REQUEST FOR INFORMATION **DATE:** October 18, 2016 **NO.:** RFI-328

Project Name: 15051-Webster University Interdisciplinary Science Building

Subject: Additional information for Overhead Service Carrier framing

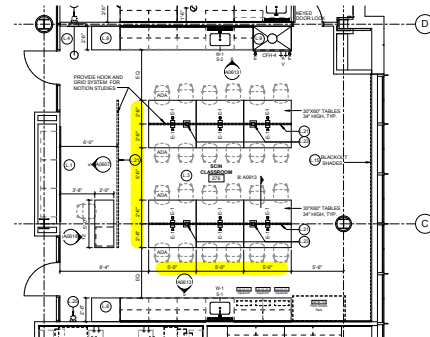
C.20 on A0702.A calls for unistrut mounted to ceiling with steel angle hangers and kickers above for support. This is shown in rooms 284 and 276. To have these struts manufactured we need additional information.

The strut fabricator requests additional information on the Overhead Service Carrier framing including length of unistrut.

This is a standard Unistrut system.
Please have fabricator submit a system proposal for review.
See sheet A0203 for length of unistruts.
GC to coordinate with sprinklers & lights.
